Historic Architectural Review Commission Staff Report for Item 3

Application Number: C2025-0057

Address: 417 Elizabeth Street (rear)

Description of Work:

Proposed Site Plan showing areas to be demolished.

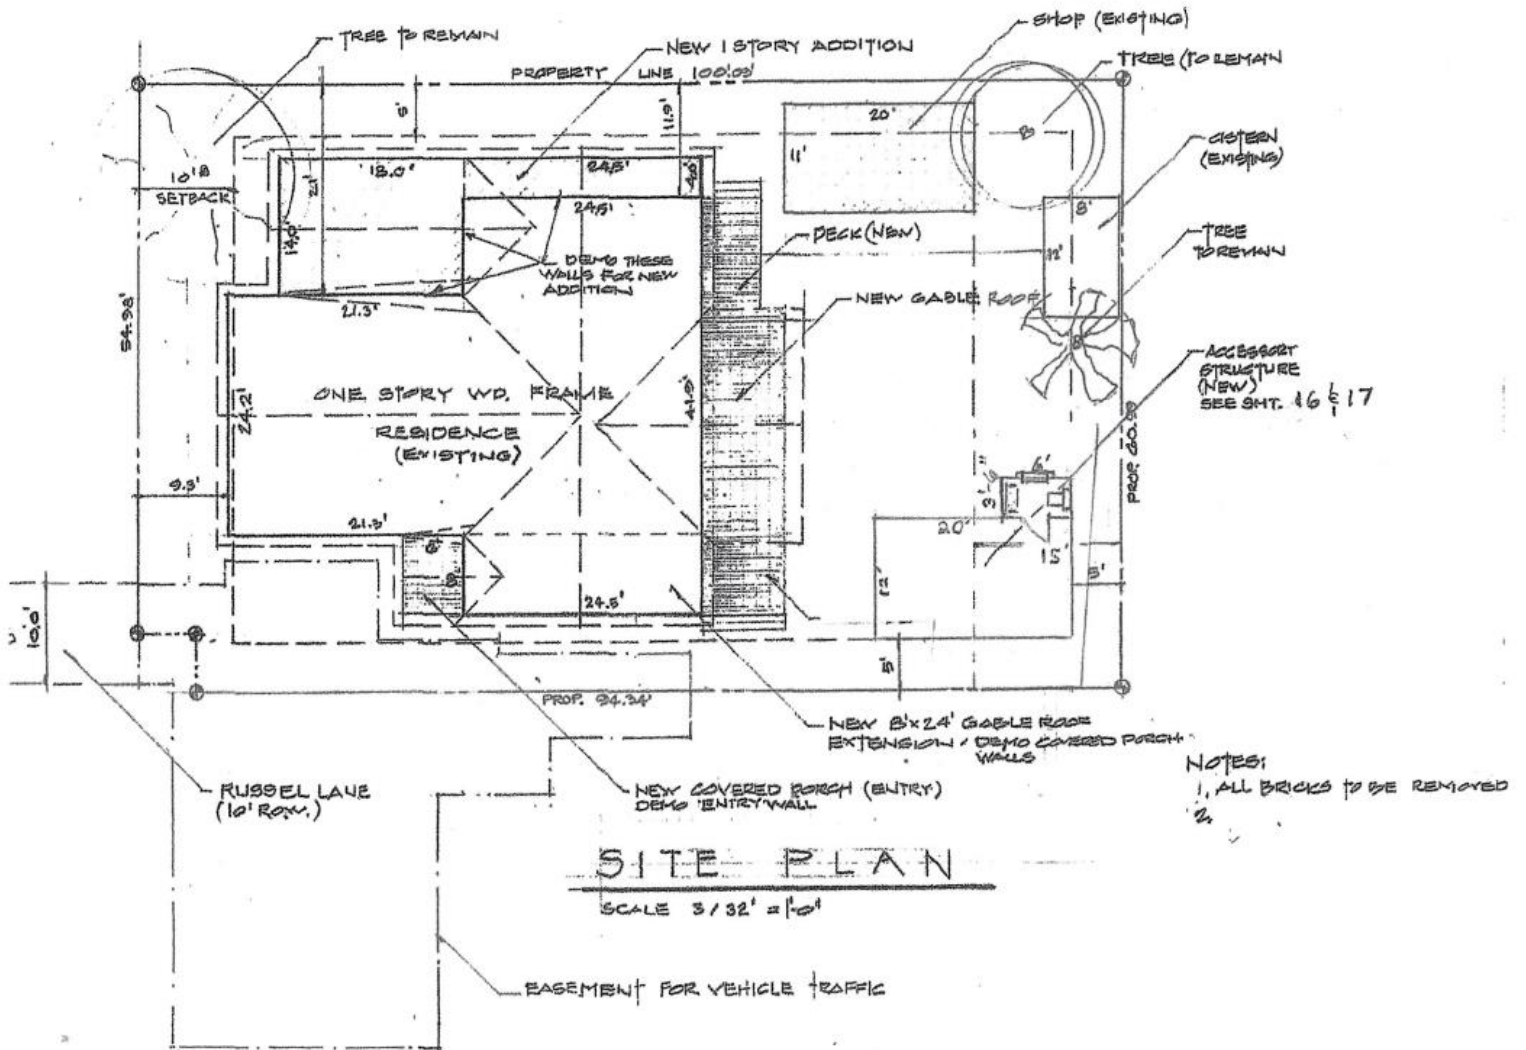
The existing enclosed porch on the south elevation is proposed to be demolished to extend the existing gable roof in the same footprint. On the west elevation facing Russell Lane, the existing entry wall will be removed to allow for the construction of a new covered front porch. The north elevation will undergo demolition of the existing porch and adjacent exterior walls to accommodate the new one-story addition. A portion of the existing roof on the east elevation will be removed to integrate the proposed covered porch. The existing pool is proposed to be removed. Additionally, the existing brick on site will also be removed on east and west sides.

It is staff opinion that the request for demolition can be considered as it meets the criteria for demolition, however, taking into account that the contributing structure does not exhibit extreme deterioration. If approved, this will require two readings for demolition as the building is contributing to the historic district. Staff will review submitted construction plans for demolition and design to assure consistency with submitted drawings.
